From: Nair, Gopakumar [GNair@oaklandnet.com]
Sent: Tuesday, July 12, 2005 2:33 PM
To: Chan, Barney, Env. Health
Subject: Oakland Municipal Service Center project update

Subject: Fuel Leak Case RO0000293, Municipal Service Center, 7101 Edgewater Dr.,
Oakland, CA 94621

Alameda County Environmental staff has reviewed the case file for the subject site including the December 7, 2004 Semi-Annual Groundwater Monitoring Report by Levin Fricke and determined that additional information is needed at your site to progress toward case closure. We are concerned that you have failed to submit the work plan for enhanced bioremediation for Plume A and further investigation of conduits at this site and the conduit/plume site map, requested submitted by January 10, 2005 in our December 8, 2004 letter.

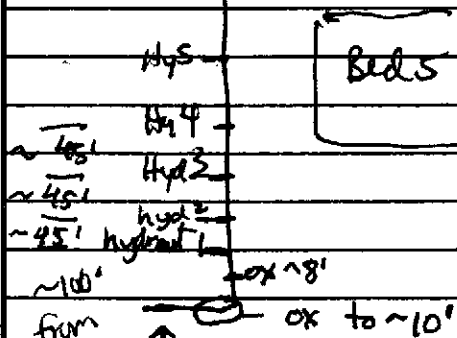
under #3 - apparent fuel release
under #2 - apparent diesel release
under #1 - oily-gas odor

Are excavating the sandy material from
pipeline, should also exc. beneath the hydrant
+ sample beneath them

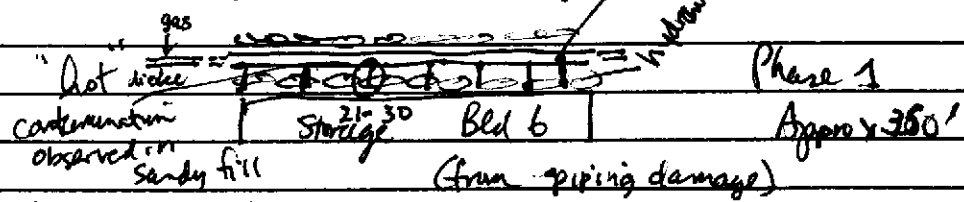
Some fuel odors + water observed in trench
will sample on 9/23/98, Piping approx 3-4' bgs
Turn Key Construction - contractors - Jerry McCasland
Trench ~ 2' wide, 4' deep, piping ~ 2-3" wide
steel pipes with vinyl type wrap
hydrocarbons are ~ 50' apart
